# Access Compliance Report

## Public Rights-of-Way

### (Curb Ramps)

Intersection ID: 30550	Main Street: ARBORETUM SHOPPING CENTER DR	Side Street: PROVIDENCE RD	Location: SW
ADA ID: EEA28B1408FB	Ramp Type: PerpDiag	Initial Pass/Fail: Fail	Overall Compliance: No
Severity Score: 12.5			
Codes/Mitigation Info/Possible Solution		Field Measurements/Component Compliance

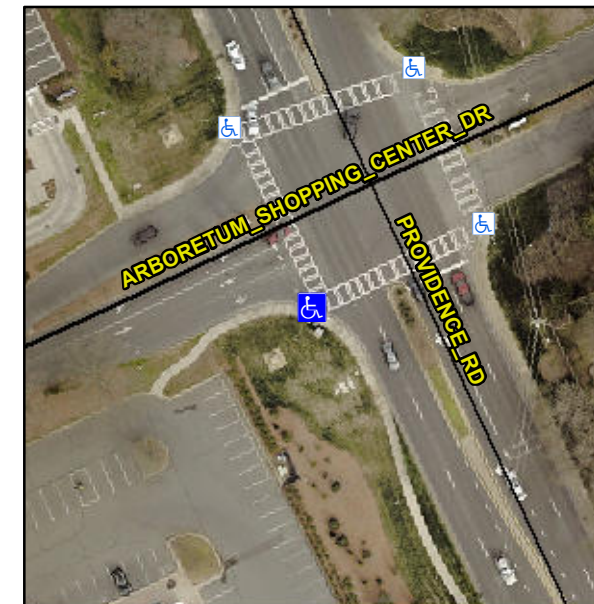
**Not Found, R304.2.2**

Compliance	Description	Data	Compliance	Description	Data
N/A	Ramp Length (in)	62.0	No	Ramp Slope (%)	9.6
Yes	Ramp Width (in)	52.0	Yes	Ramp XSlope (%)	0.2
N/A	Flare Type LT	N/A	N/A	Flare Type RT	N/A
N/A	Flare Slope LT (%)	N/A	N/A	Flare Slope RT (%)	N/A
N/A	Flare Traversable LT?	N/A	N/A	Flare Traversable RT?	N/A
N/A	Landing Length (in)	N/A	N/A	DWS Provided?	N/A
N/A	Landing Width (in)	N/A	N/A	DWS Contrast?	N/A
N/A	Landing Slope (%)	N/A	N/A	DWS Length (in)	N/A
N/A	Landing X Slope (%)	N/A	N/A	DWS Full Width?	N/A
N/A	Landing Curb? (Y/N)	N/A	N/A	DWS Offset (in)	N/A
N/A	Shared Landing?	N/A			
N/A	Gutter Ponding?	N/A	N/A	Gutter Slope (%)	N/A
N/A	Gutter Lip Ht (in)	N/A	N/A	Gutter X Slope (%)	N/A
N/A	Painted X Walk1?	Yes	N/A	Painted X Walk2?	Yes
	X Walk 1 Direction	To NE		X Walk 2 Direction	To NW
N/A	X Walk 1 Width (in)	103.0	N/A	X Walk 2 Width (in)	94.0
	X Walk 1 Slope (%)	0.6		X Walk 2 Slope (%)	2.0
	X Walk 1 X Slope (%)	0.5		X Walk 2 X Slope (%)	1.8

**Remove & Replace Curb Ramp With Two New Directional Ramps or Equivalent. Restripe Crosswalk.**
